SPI Programming Failure Modes in Specific Use Scenarios with Platform Manager 2, MachXO2, and MachXO3 Products and Work-Around Solutions

Figure 1. Issue #1: Race Condition between CSn and MCLK

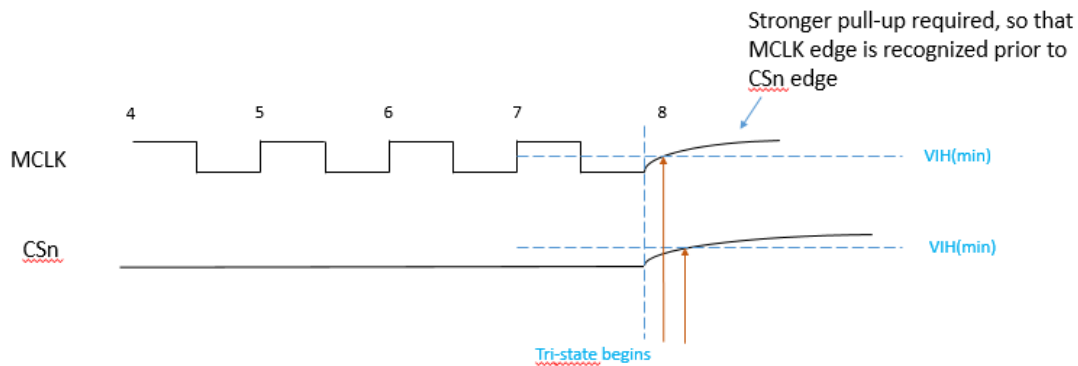
Issue #1: Race condition between CS and MCLK at the end of SPI transaction

This race condition occurs when the JTAG-to-MSPI bridge is used to erase/program/verify the external SPI device. The JTAG command to release control of the SPI embedded function block (EFB) will disable both CS_n and MCLK outputs at the same time. If CS_n wins the race, the SPI device does not see the final MCLK edge. In this situation, the SPI device ignores the final data or command and a programming error occurs. By using different strength pull-ups resistors, MCLK can be forced to rise before CS_n (as shown in Figure 1), to prevent programming errors. Lattice has historically recommended that MCLK use an external 1 k pull-up resistor (FPGA-TN-02154 MachXO2 Hardware Checklist and FPGA-TN-02155 MachXO2 Programming and Configuration User Guide) and CS_n relies on the weak pull-up of the I/O or an external 10 k pull-up resistor that is recommended in FPGA-TN-02078 Dual Boot and Background Programming PM2. Therefore, if the existing recommendations are followed, this issue should not be encountered for most customers. It is possible that resistor values must be adjusted depending upon design dependent routing and trace loads in order to ensure proper edge relationships.
